# **CW PIPELINES - PERMANENT EASEMENT REPORT**

**KILLINGHOLME POWER STATION**

**JULY 2012**

**Capita Symonds  
6, Bowood Court  
Calver Road  
Warrington  
WA2 8QZ  
Tel: 01925 418333**

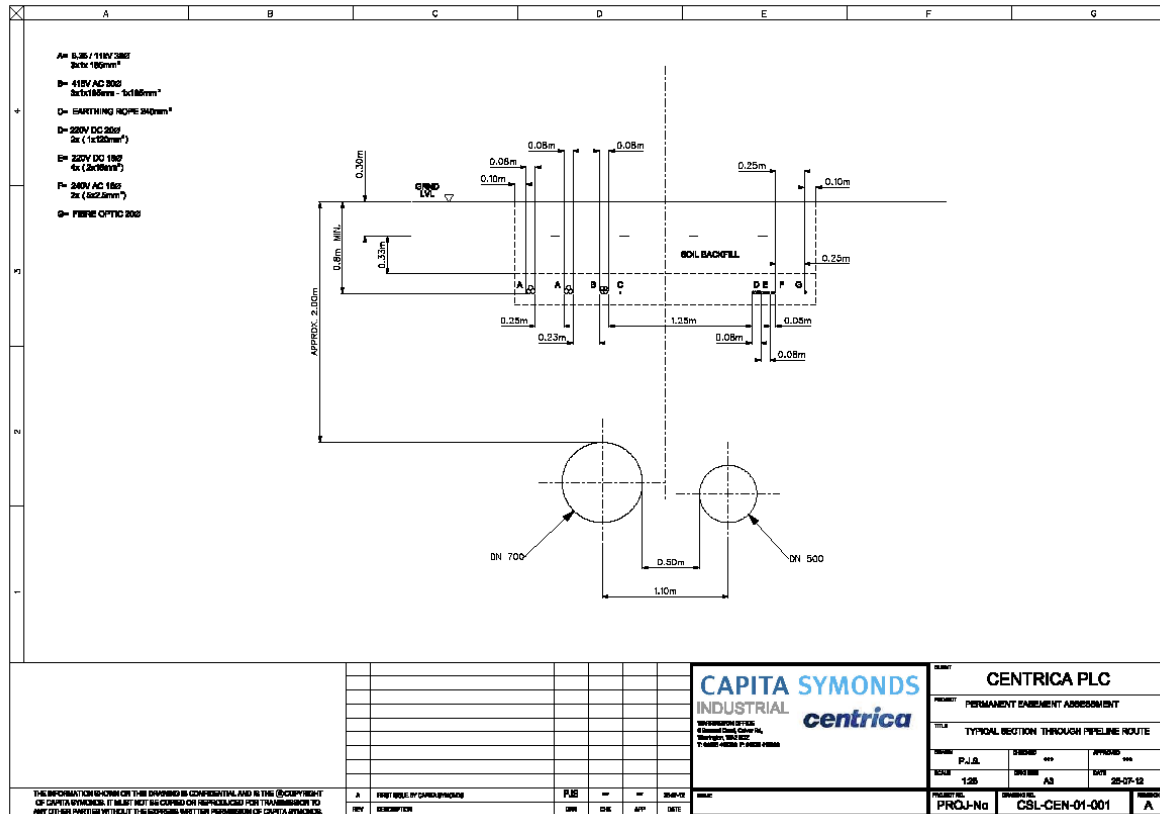
The corridor contains two large bore pipes (Nb 700mm and 500mm) offset by approximately 500mm. These pipes are laid with an original cover of approximately 1.8m to 2.0m. However Centrica plc are aware that the original ground level has been raised by up to a further 2m along large sections of the route. Immediately above the pipelines there are 21 no. electrical/earthing/fibre optic cables. (See below – Drg No: CSL/CEN/01/001 – Typical Section Through Pipeline Route)
